Addendum #3

July 23, 2018

Project
McRAE PROPERTY DEVELOPMENT
553 BONACCORD STREET,
PETERBOROUGH, ON

Drawing Title
PROPOSED SITE PLAN
FIRE ROUTE

McRAE PROPERTY DEVELOPMENT
PROPOSED SITE PLAN: FIRE ROUTE
1
A1.3 SCALE 1:400

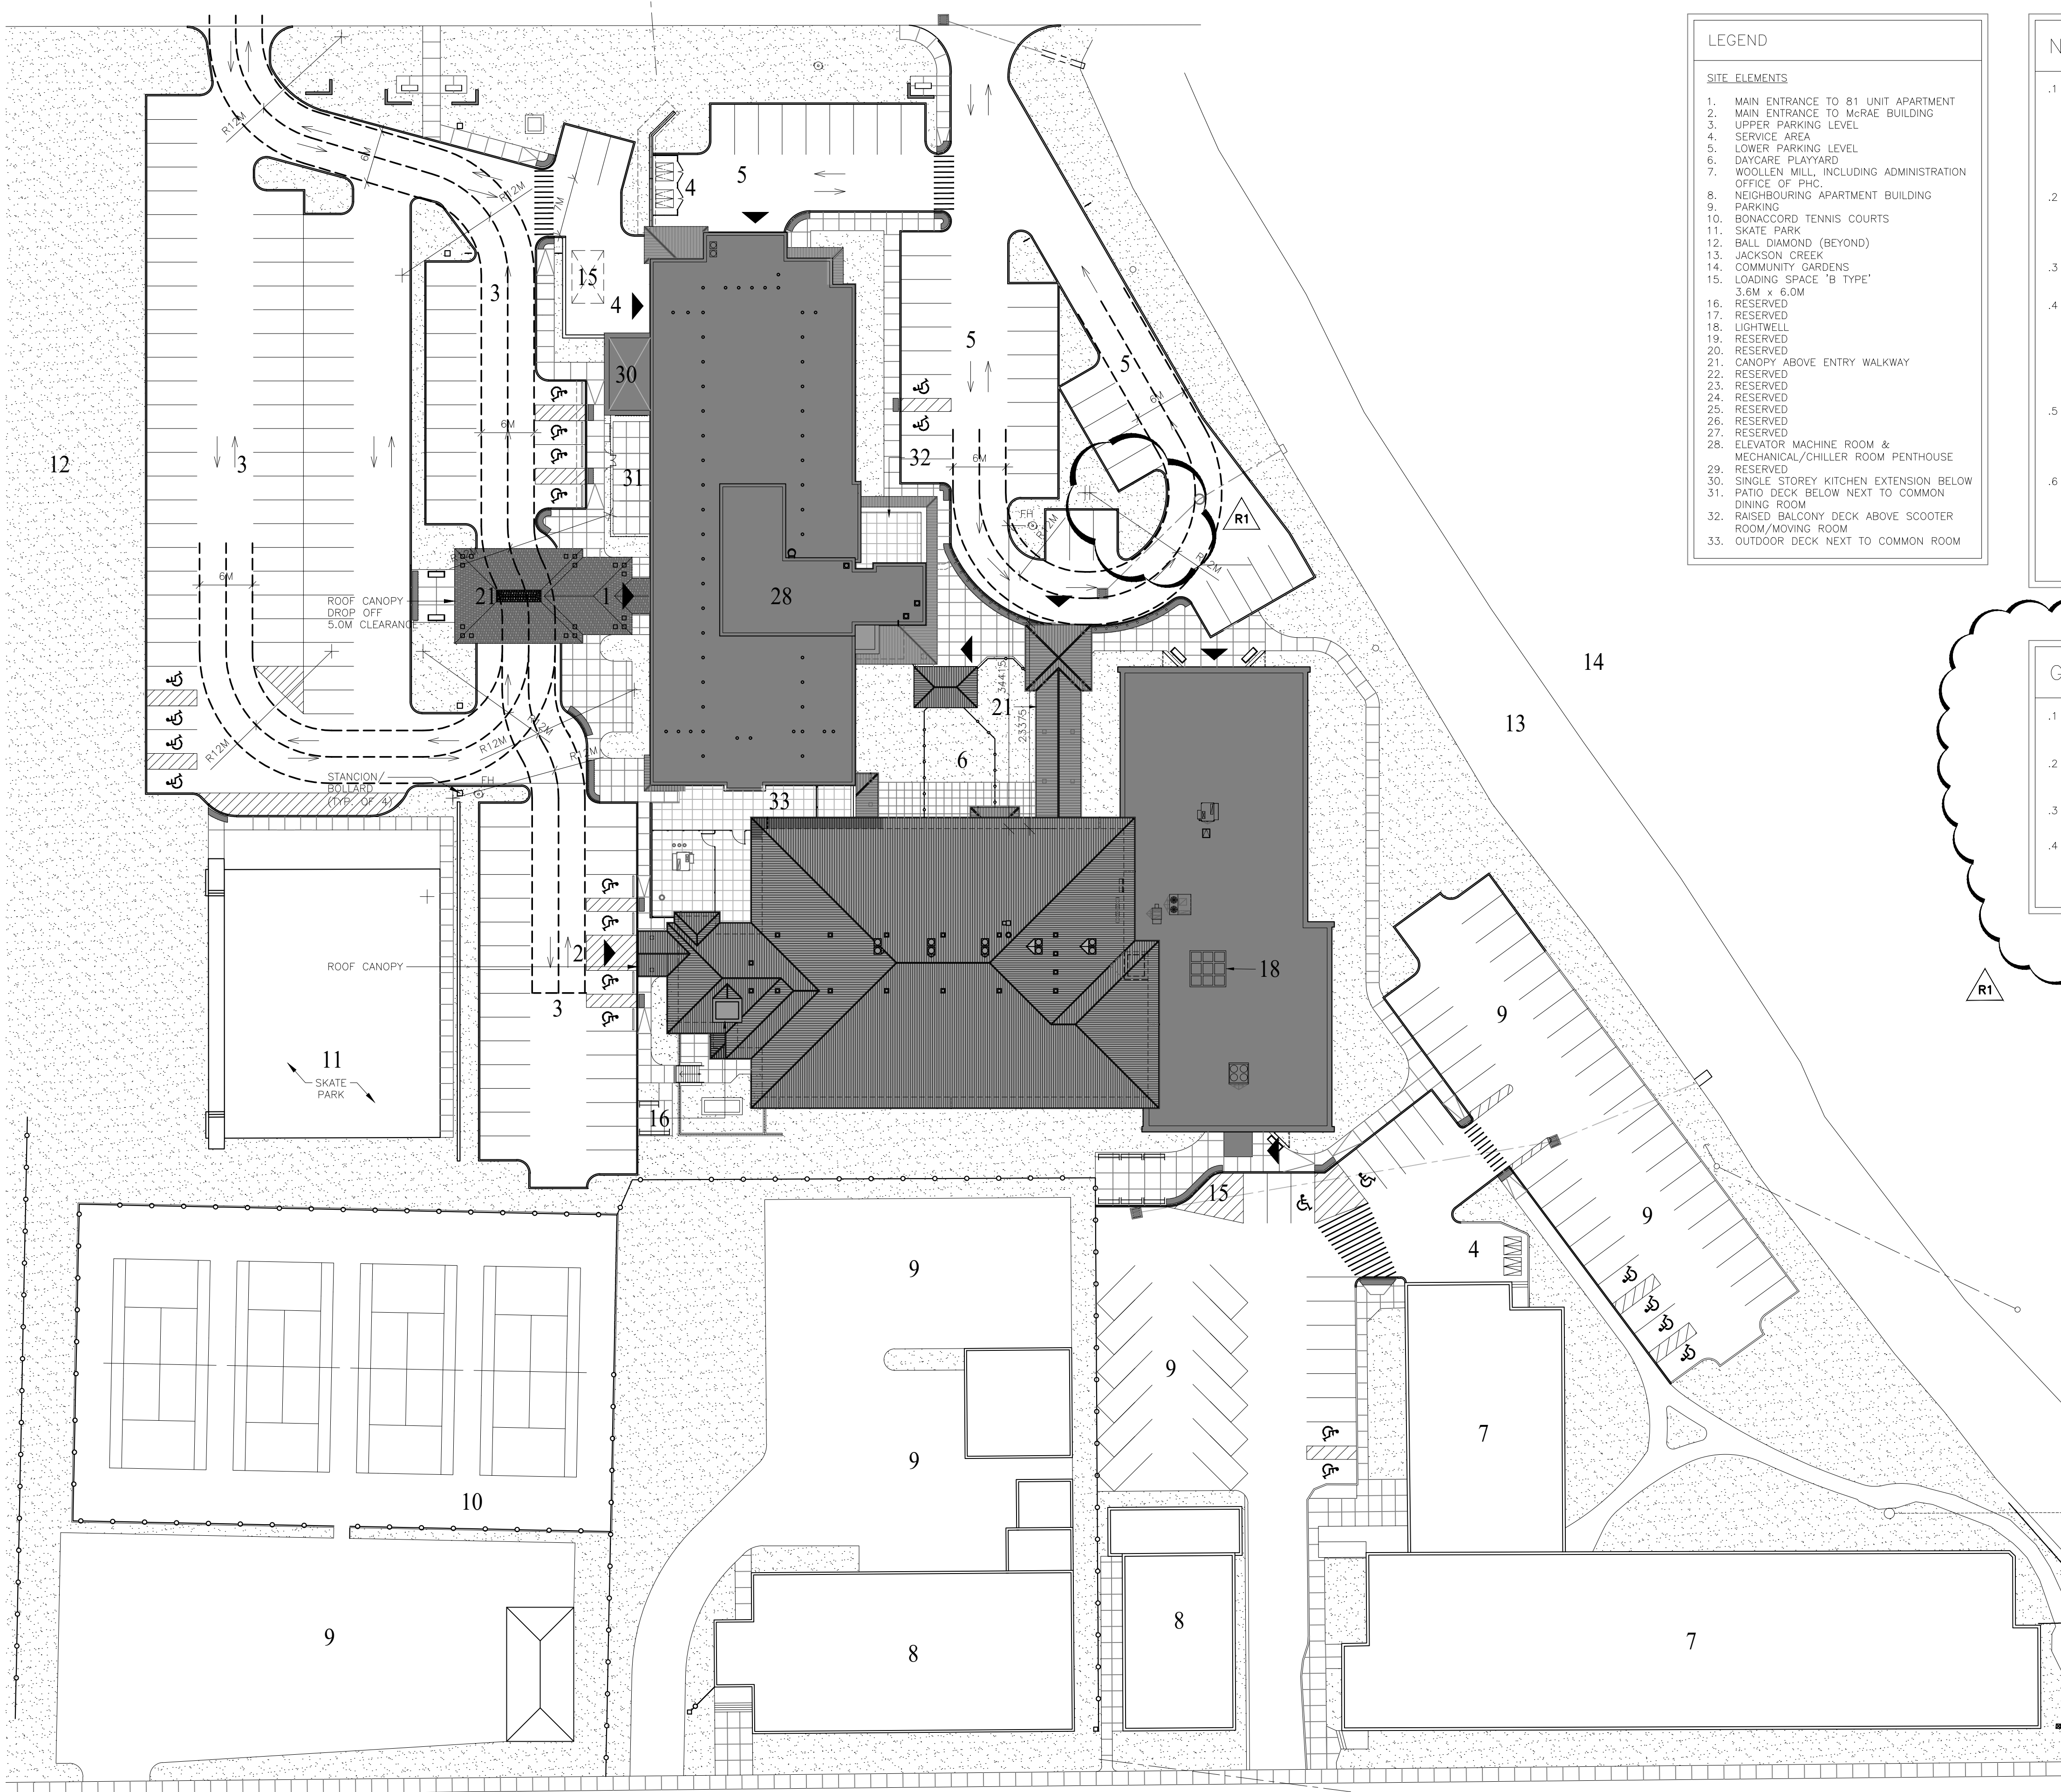
We have revised Site Plan drawing A1.3 to include an extension of the Fire Fighting Access Route to the main front entry to the McRae Building, and have included it here, attached to this Addendum #3. In order to reach within 15 m of the front entry doors to the two storey McRae Building, fire fighting vehicles will have to drive from the driveway entry on Bonaccord Street, through the upper parking lot level, directly to the canopy entry of the 81 Unit Supportive Housing Building passing below the

canopy from the north to the south and driving directly to the front of the two storey building. This will mean that in retreat from the fire, the fire fighting vehicles will have to back up a short distance but once they have backed up the short distance they can then drive in a forward motion through the City Owned Parking lot to the west and back onto Bonaccord Street.
